HISTORIC DISTRICT COMMISSION APPLICATION FOR WORK APPROVAL

APPLICATION ID
HDC2025-00054

ADDRESS(ES): 1760 Wabash
HISTORIC DISTRICT: Corktown

Window Trim and Wood Siding

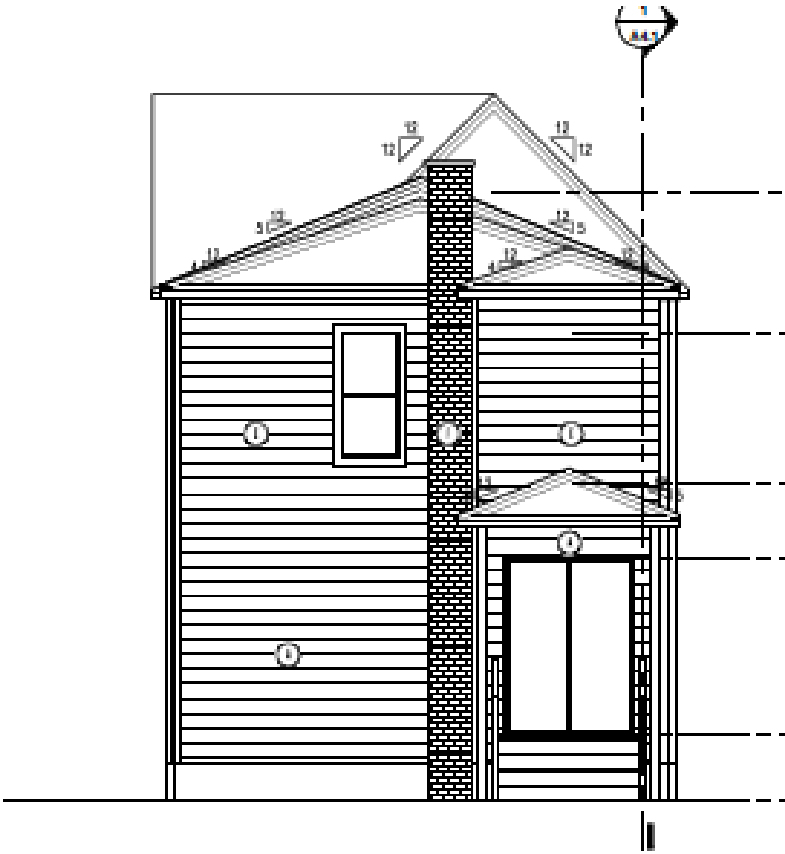
Left: Window at 1714 Bagley (similar date of construction as 1760 Bagley) 19th century houses have clearly defined window trim: butt joints, a header with a small overhang, equal-sized side trim and a narrower, protruding sill.

As identified on the first page, the window casing (covered with aluminum) exhibited this type of window casing, as did the window on the second floor, south side of 1760 Wabash. Both window's trim were replaced with flat window trim on all four sides. The change of window trim is one of the alterations that removed features one of the alterations that removed

As identified on the first page and at the top of this page, the window casings (covered with aluminum) exhibited this type of 19th century window casing. The trim on both windows were replaced with flat window trim on all four sides.

I understand the siding on the house might be wood, one problem is that it is new siding. Staff didn't approve this change and at my August site visit with you, explained the historic siding had to be retained. As seen in the photo of 1714 Bagley, historic siding shows its age – which is important.

The change of window trim and replacement of the historic wood siding are two of the alterations that removed features/examples of craftsmanship that characterized this property.

Window Trim and Wood Siding

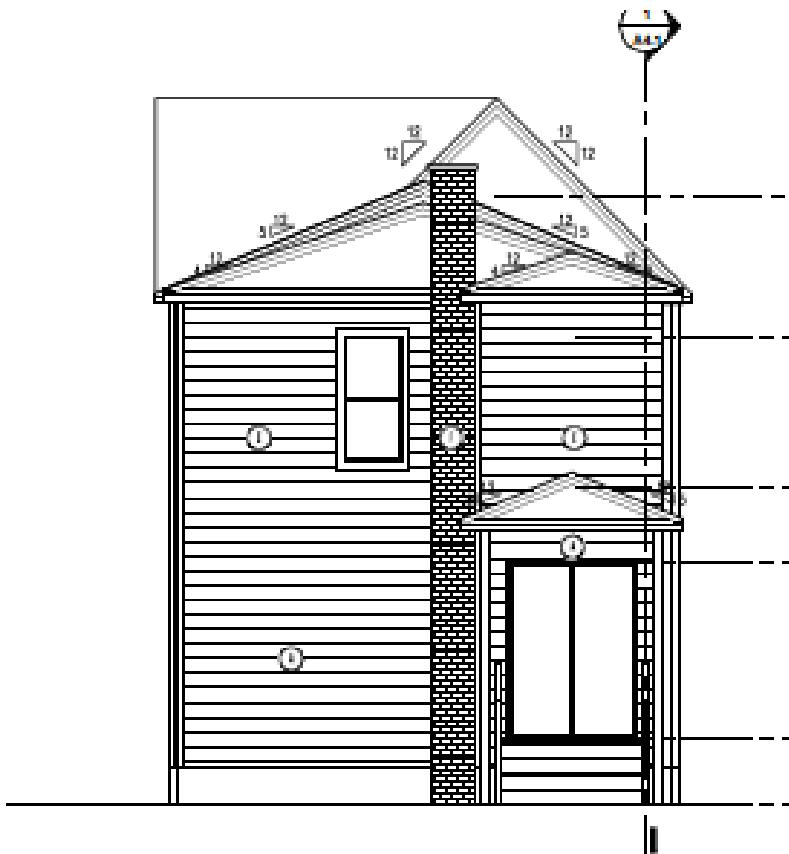
Left: Window at 1714 Bagley (similar date of construction as 1760 Bagley) 19th century houses have clearly defined window trim: butt joints, a header with a small overhang, equal-sized side trim and a narrower, protruding sill.

As identified on the first page, the window casing (covered with aluminum) exhibited this type of window casing, as did the window on the second floor, south side of 1760 Wabash. Both window's trim were replaced with flat window trim on all four sides. The change of window trim is one of the alterations that removed

As identified on the first page and at the top of this page, the window casings (covered with aluminum) exhibited this type of 19th century window casing. The trim on both windows were replaced with flat window trim on all four sides.

I understand the siding on the house might be wood, one problem is that it is new siding. Staff didn't approve this change and at my August site visit with you, explained the historic siding had to be retained. As seen in the photo of 1714 Bagley, historic siding shows its age – which is important.

The change of window trim and replacement of the historic wood siding are two of the alterations that removed features/examples of craftsmanship that characterized this property.
